UNITED STATES PATENT AND TRADEMARK OFFICE

APPLICATION NO.	FILING DATE	FIRST NAMED INVENTOR	ATTORNEY DOCKET NO.	CONFIRMATION NO.
10/726,760	12/03/2003	Thomas Korner	DKT02164	4211

Office Action Summary	Application No. 10/726,760	Applicant(s) KORNER, THOMAS	
	Examiner Thai-Ba Trieu	Art Unit 3748

DETAILED ACTION

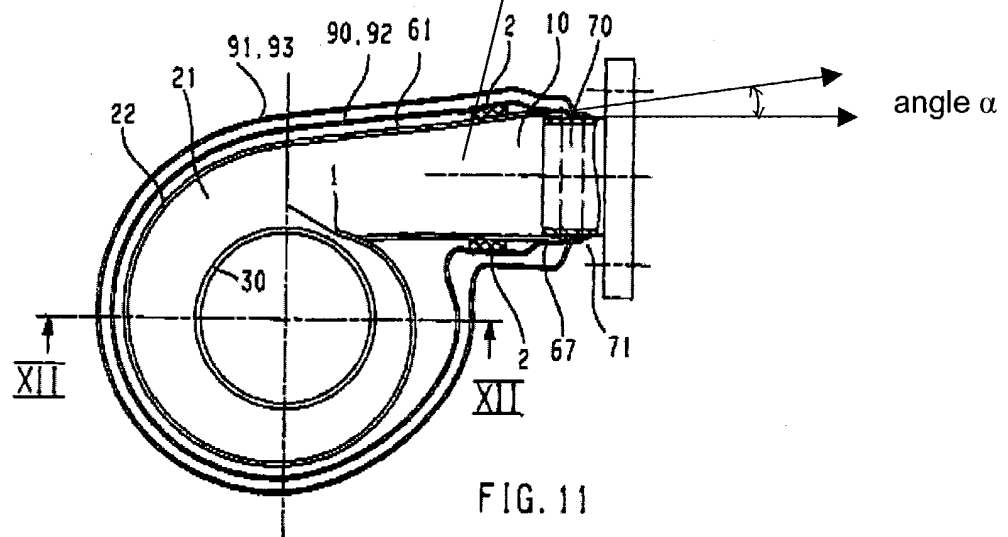
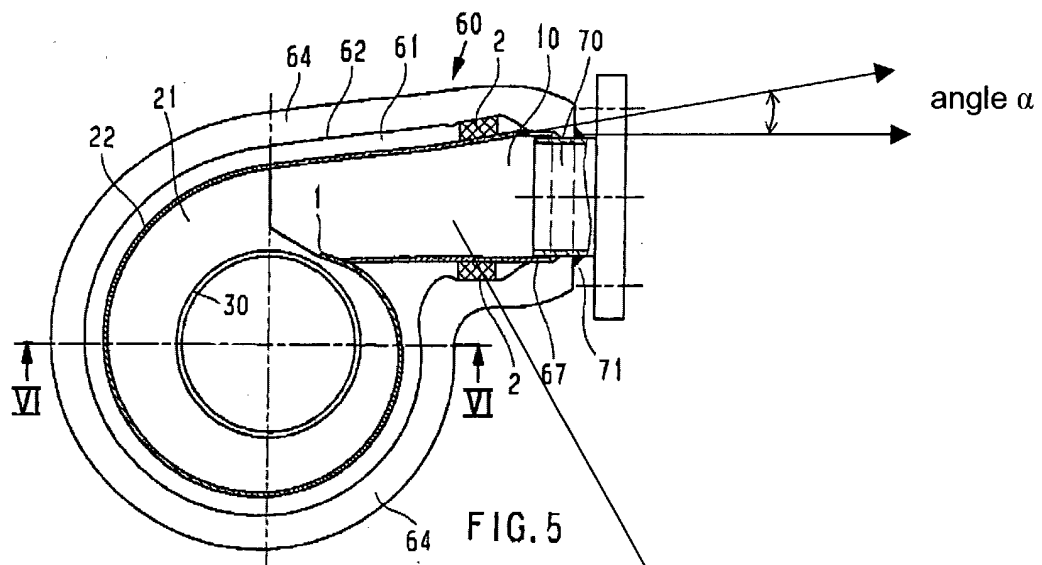
a cylindrical portion into which the tubular end of the respective other element, the tubular connection element (70), inserted, the conically widened portion advantageously having an angle (α) of at most 30° , of at most 20° , and at least 7° and whereby the inner surface the cylindrical portion abuts onto the outer surface of the connection pipe means (See attached Figures 2, 5, and 11; Column 4, lines 52-58, and Column 5, lines 32-36); and

said heat conducting connection comprising a cylindrical portion (See attached Figure 5) of one of the tubular elements, the housing jacket (22, 23, 62, 63) into which the tubular end of the respective other tubular element, the connection pipe means (70), is insertable, wherein the inner surface of the cylindrical portion abuts onto the outer surface of the connection pipe means (70) (See attached Figures 2, 5, and 11; Column 4, lines 52-58, and Column 5, lines 32-36);

said housing jacket (22, 23, 62, 63) consisting at least two layers of metal sheet arranged one on top of the other, whereof preferably the outer one (60, 62, 63) is thicker than the inner one (22, 23) (See attached Figure 5); and

two mutually complementary spiral portions being connected to each other by welding (See Figures 5 and 11, Column 2, lines 34-39).

Not that from the Figures 5 and 11 of Manfred, the angle (α) is to be in the range of at most 30° , of at most 20° , and at least 7° , as applicant claims in claims 4, and 11-12.
